14 Lincoln Place Cinema Building, Madison, NJ

Historic Preservation Review

Thornton Tomasetti Project No. F19022.00

February 11, 2019

Photo 10: View up at theater ceiling. Where damaged acoustical tiles have fallen, moist pink fiberglass insulation is visible and beyond, original ornamental plaster is moisture damaged and friable.

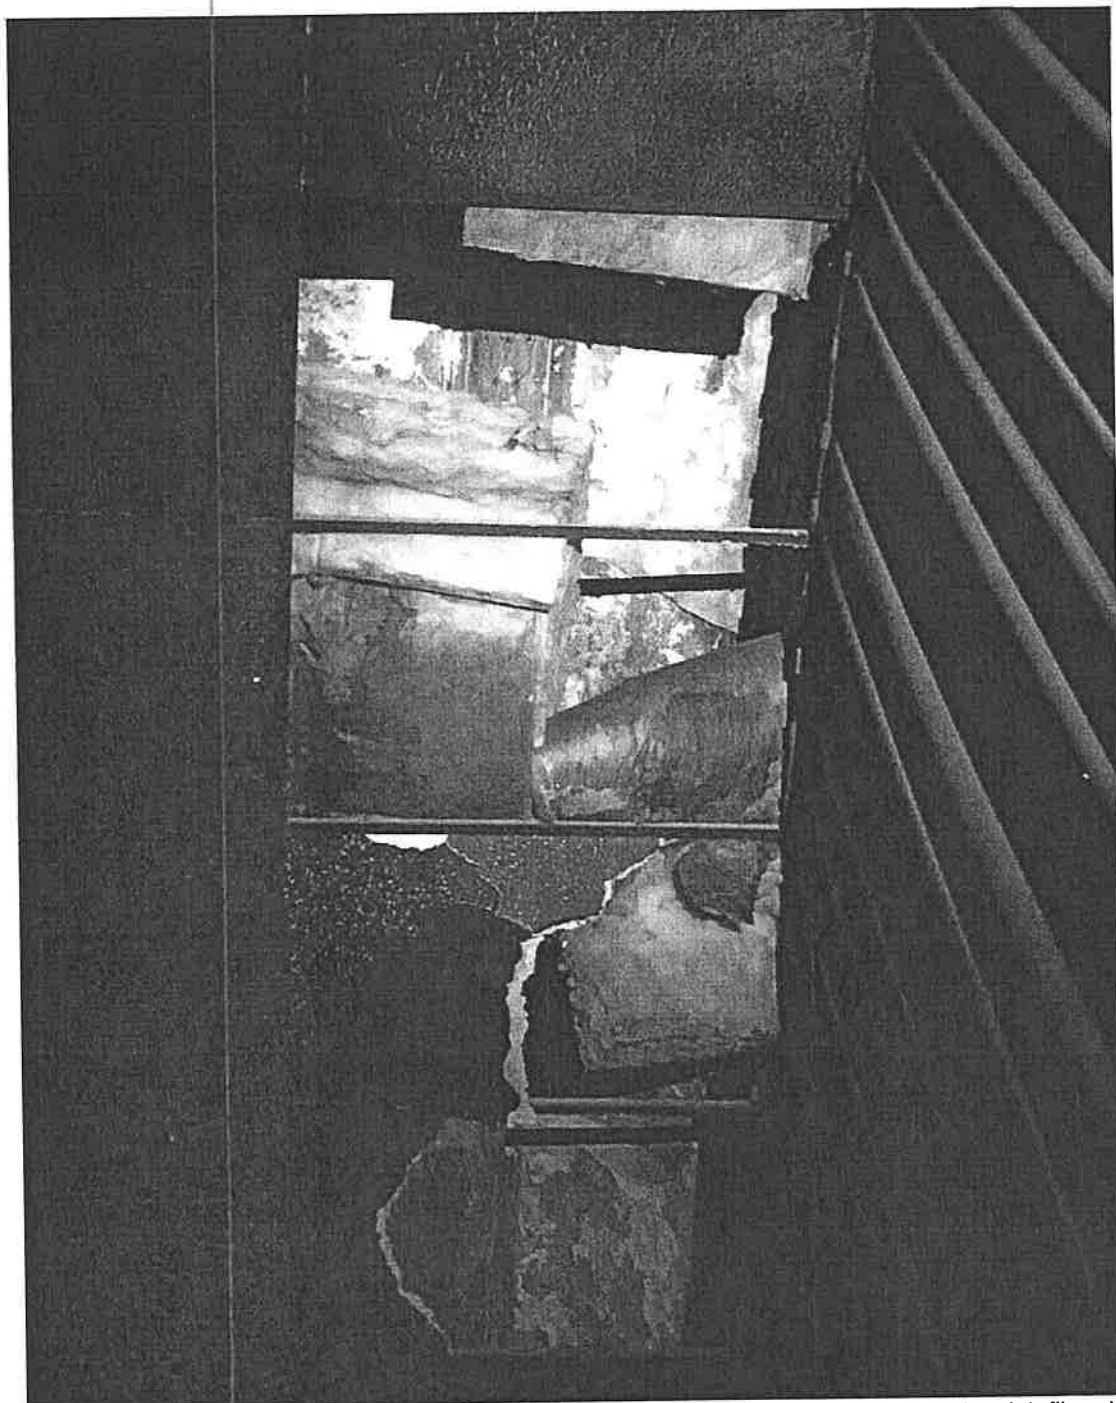
- c. Moisture damage was observed at the first floor ceiling, at lobby areas (see Photos 7-9) and in the theaters. In the theaters, there are suspended acoustical ceilings beneath the original ornamental plaster ceilings. There are a number of areas where acoustical panels have fallen due to falling plaster from above, the weight of saturated fiberglass insulation and other causes (see Photo 10). Visible areas of ornamental plaster are moisture damaged and appear friable.

Photo 15: Corroded lintel at louver opening. Steel is bowed, delaminated and has caused damage to masonry at the jamb from rust jacking.

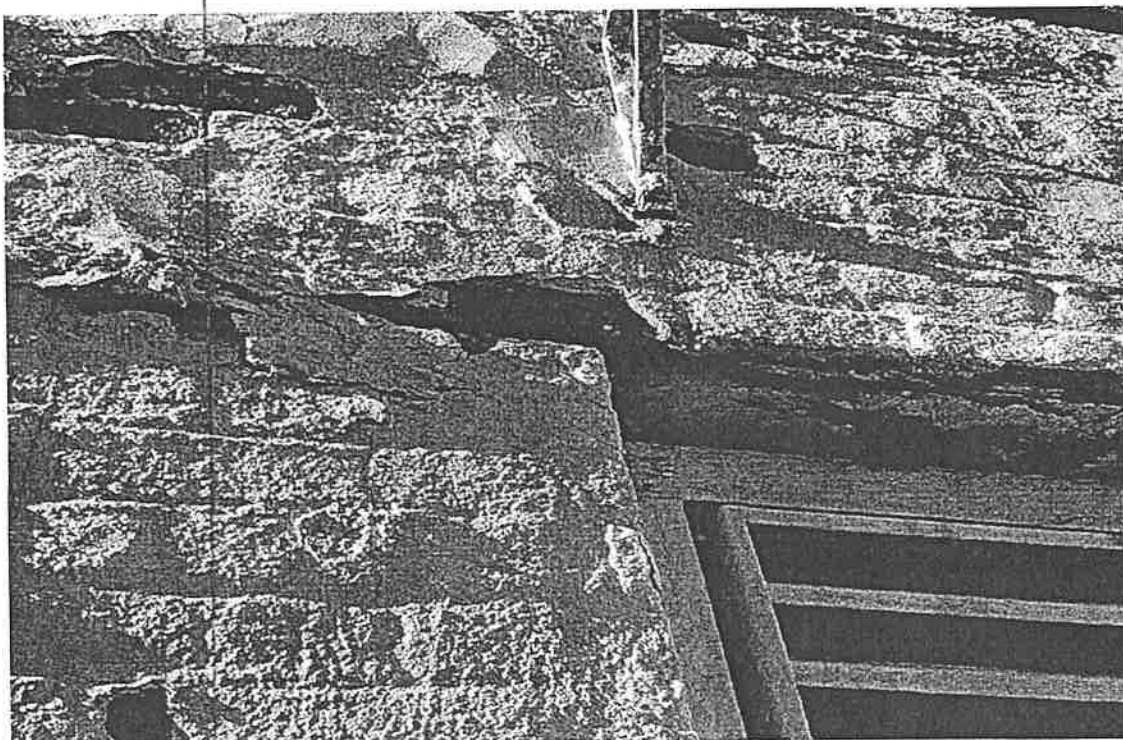
have contributed to widespread failure of the wall as a moisture barrier and greatly diminished the material integrity of the face brick. Ferrous metal items such as lintels have corroded throughout. Some have bowed and/or delaminated and many have rust jacking that has damaged bearing masonry at the jambs (see Photo 15).

Photo 17: GW contextual comparison analysis.

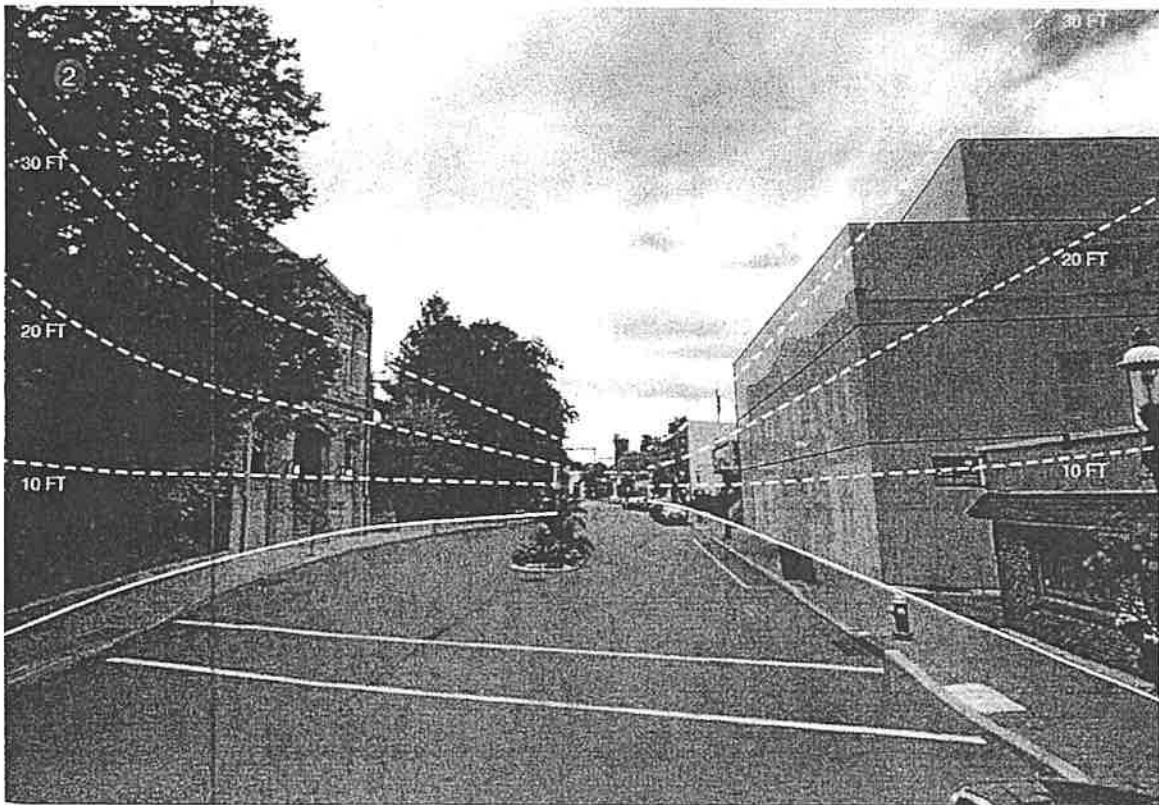
- Size and Scale: The size and scale are comparable to key storefront buildings in the district, which range from a smaller size to ones larger than the proposed building. The massing, proportions, height and volume are consistent with the range of storefront buildings in the district. The scale complements the train station across the street and the storefront at 6 Lincoln Place and recalls the characteristics of key commercial buildings in the District (see Photos 17 and 18).

Photo 19: GW model of proposed building facade

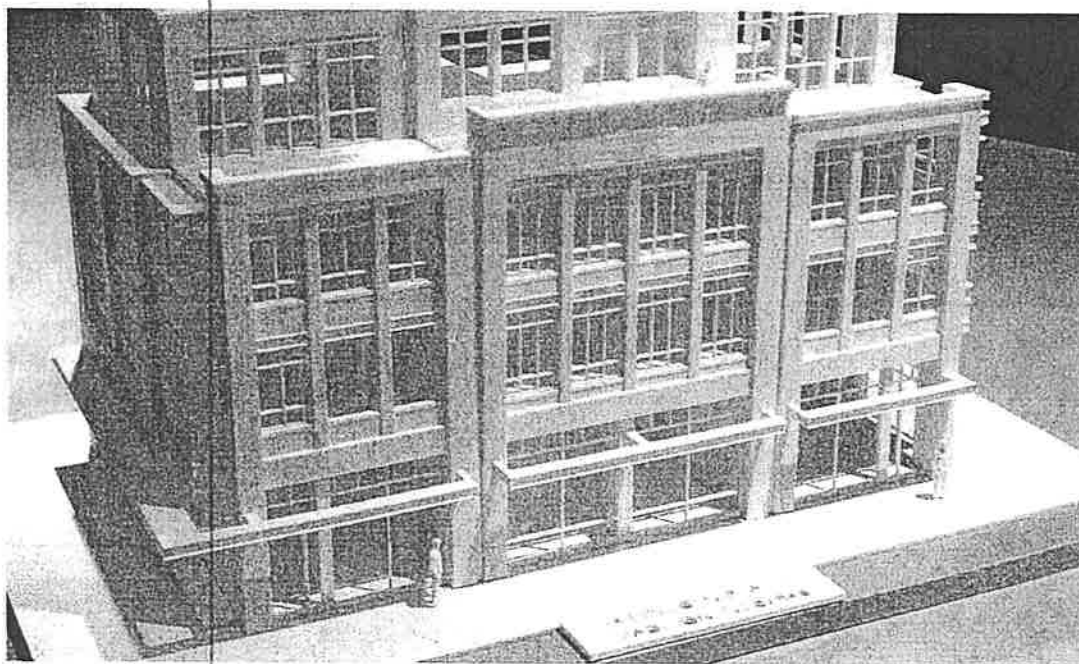
that recalls solid masonry wall construction. For directional emphasis, the design reflects a skillful use of horizontal and vertical elements that have a sense of balance. The interplay of horizontal and vertical elements is clearer in the model than the drawings (see Photo 19).
